KERR-McGEE CORPORATION

APPLICANTS ENVIRONMENTAL REPORT

URANIUM HEXAFLUORIDE PLANT

SUPPLEMENTAL #2

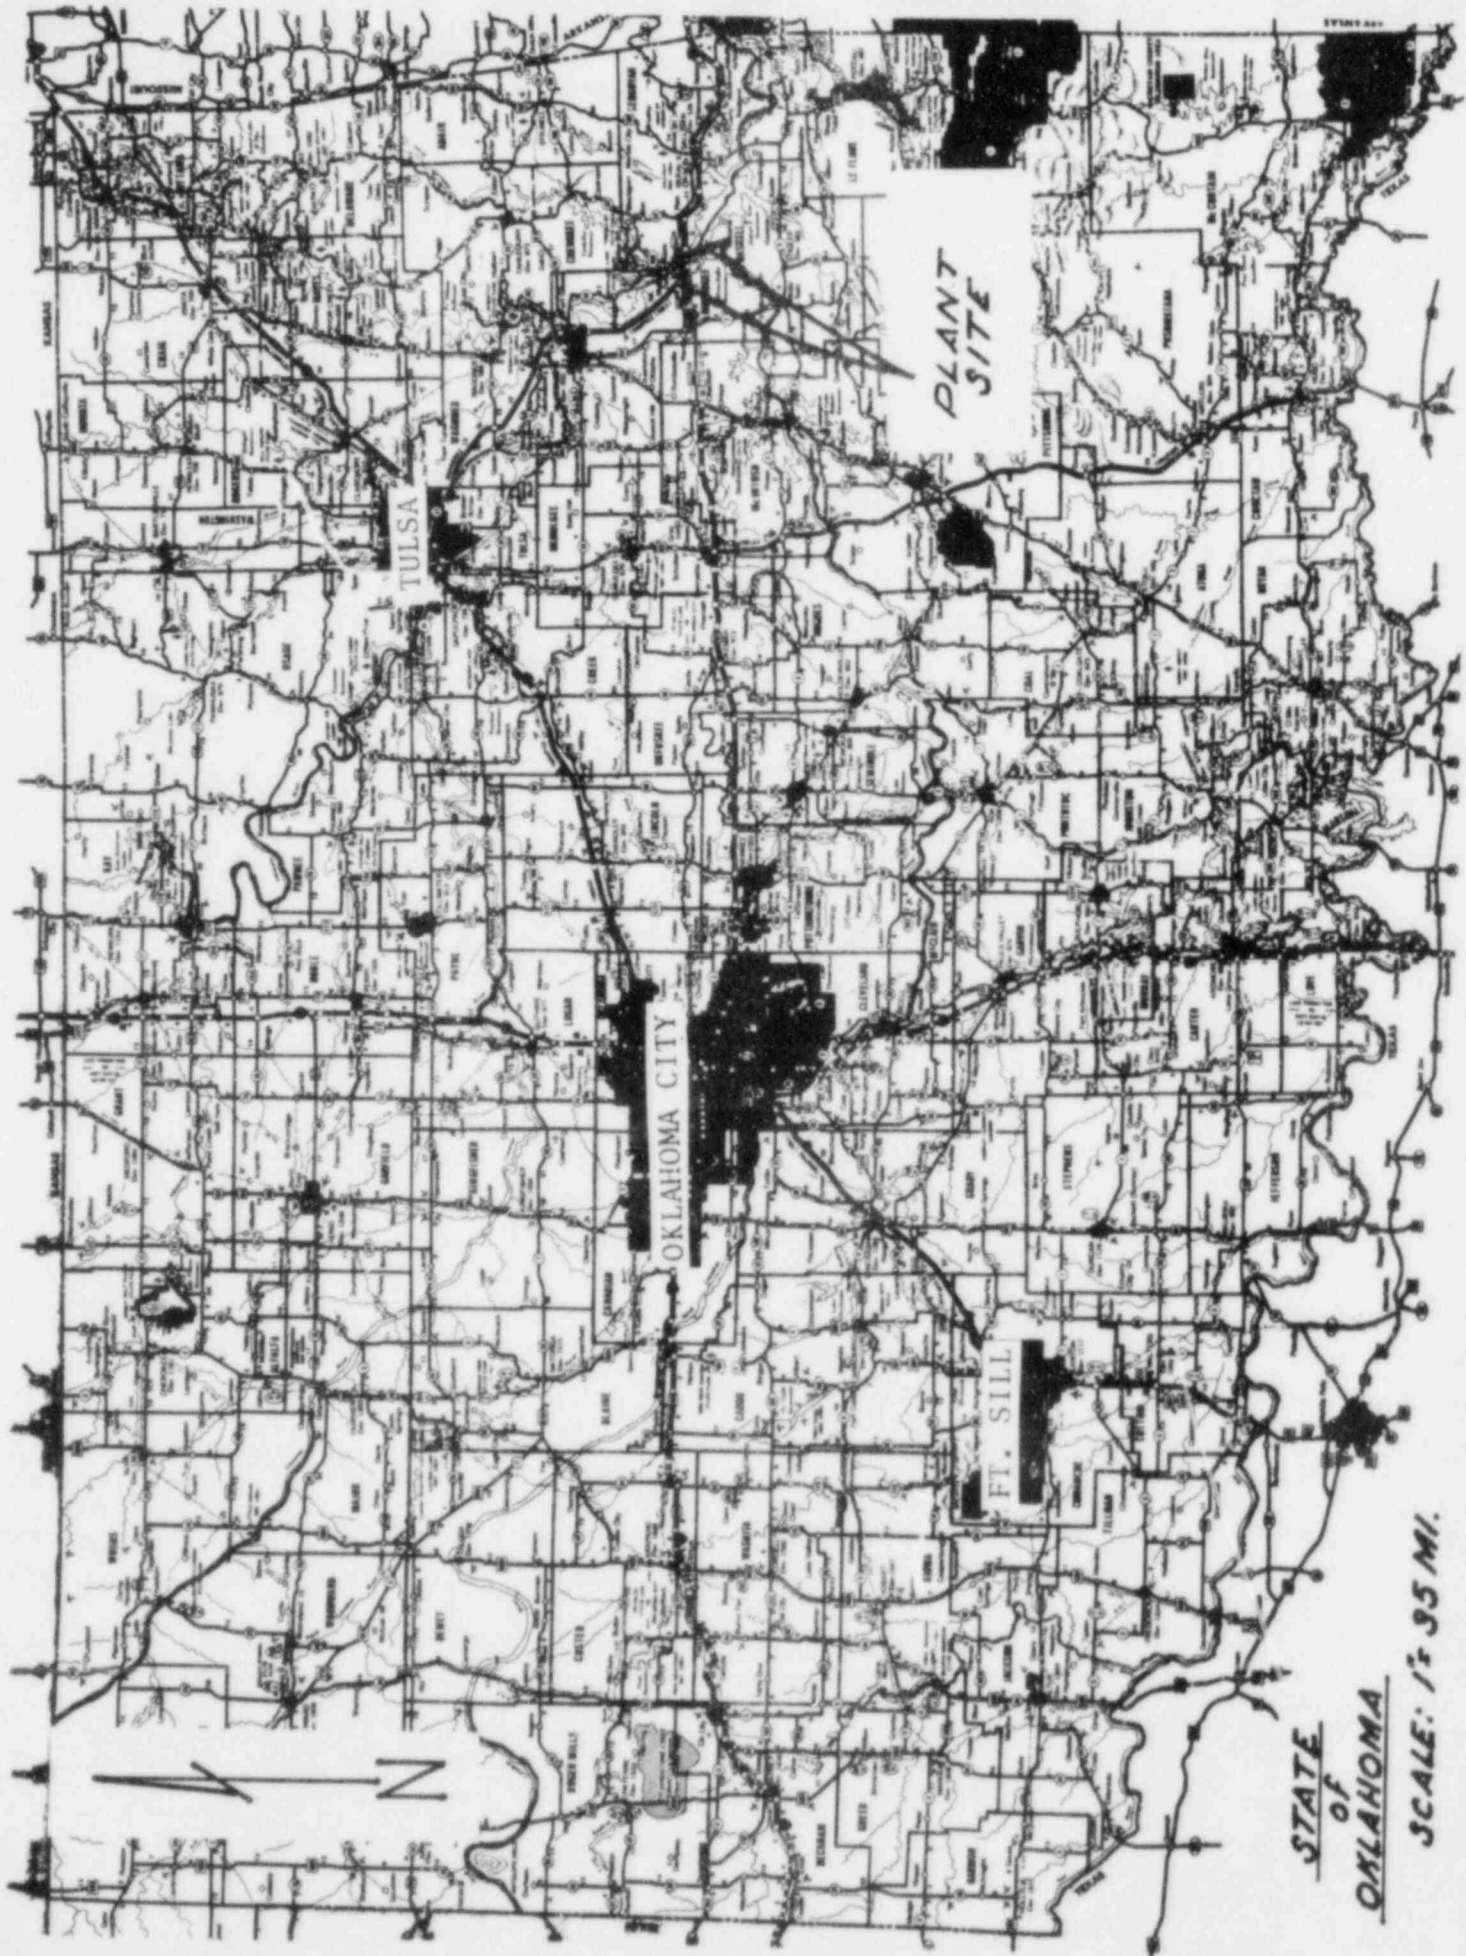
- (2) Maps provided (Figure 1 in particular) are not very clear. Suggest substituting following 8 x 10 1/2" drawings:
- (a) General map of State of Oklahoma pointing out plant site (scale about 50 miles per inch),
  - (b) Second map showing general area details i.e., towns, roads, rivers, etc. (scale about 10 miles per inch)
  - (c) Third map similar to insert in present Figure 1. (scale about 4 miles per inch)
  - (d) Plant area map (scale about 1500 feet per inch) up-dated to show all existing ponds, monitoring points, residences, etc. alone with distances from air-borne effluent release point to possible critical exposure points; e.g., school, homes, roads.

The maps requested are enclosed. We feel, however, that this request, if such fixed criteria for such reports exists, should be included in the guidelines for such reports. Figure 1 is a reduction of Drawing 110-C-151 included with the Revised Environmental Report. The location of the houses and school are circled and the distances tabulated.

SEQUOYAH FACILITY  
X - SECTION  
THROUGH HOLDING PONDS  
NOTE: VERT.-EXAG. 5:1  
12/72

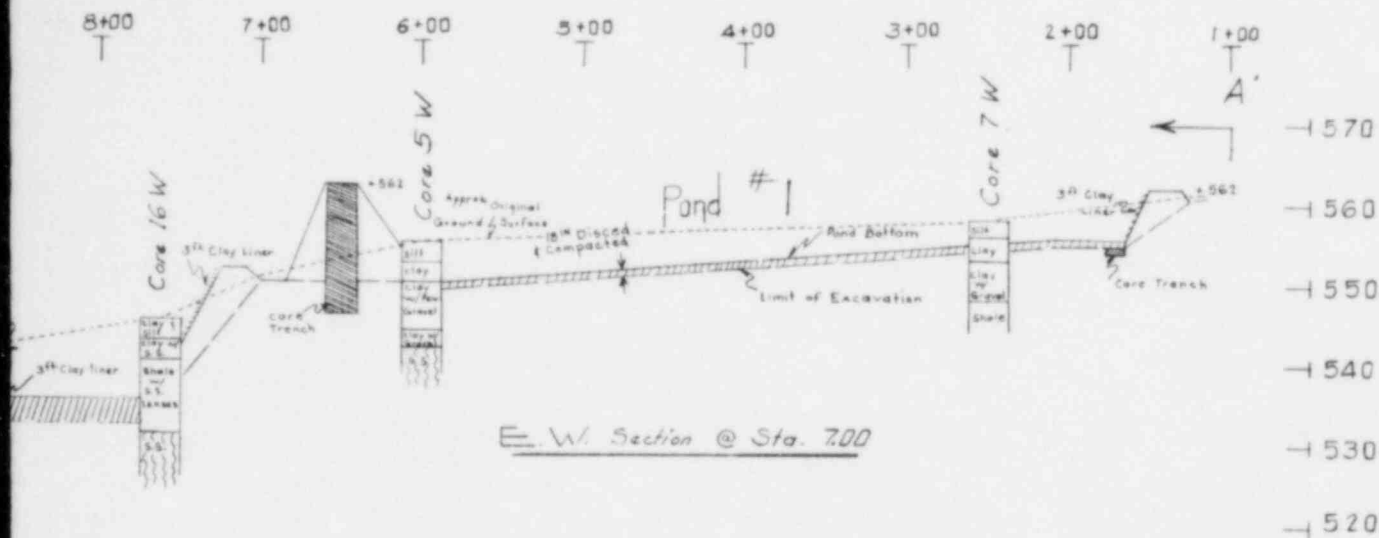
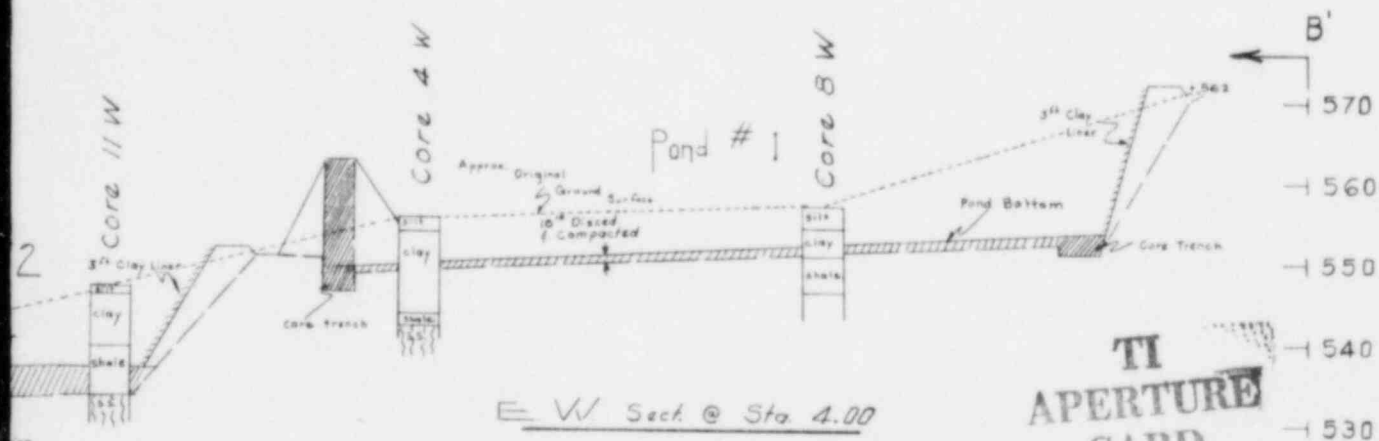
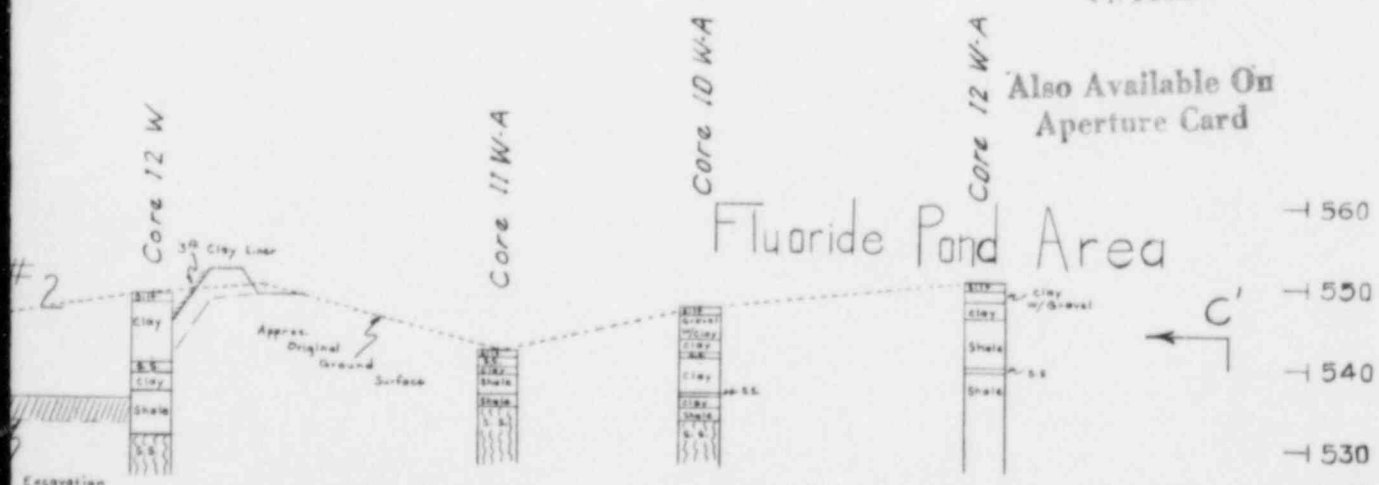
Dr. Warner again raises questions as to the integrity of the raffinate ponds and the apparent contamination of monitoring well water. Please see the attached discussion for more detailed explanation.

This discussion describes more fully the examinations made, the construction of the ponds, and the monitoring well analysis so as to provide assurance that these ponds are not leaking contaminated material into the ground.

As described briefly under question 38, clay linings and dike facings were subjected to permeability tests by standard methods

employed by soil engineers, demonstrating essentially no permeability to raffinate fluids exists as shown on the attached report by Hemphill Drilling Co.
